Access Compliance Report

Public Rights-of-Way

(Curb Ramps)

Intersection ID: 14442	Main Street: N_SHARON_AMITY_RD	Cross Street: CENTRAL_AV	Location: SW
ADA ID: 9F8274800FDF	Ramp Type: Para	Initial Pass/Fail: Fail	Overall Compliance: No
Severity Score: 13.75			
Codes/Mitigation Info/Possible Solution		Field Measurements/Component Compliance

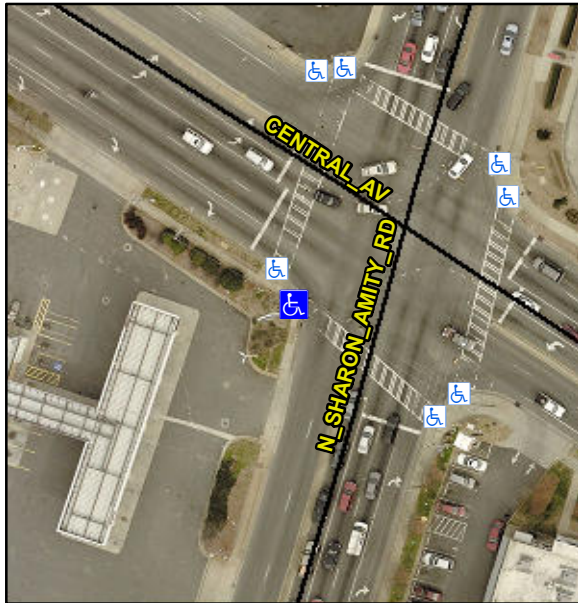
Remove & Replace Entire Ramp.

R304.3.2, R304.5.3
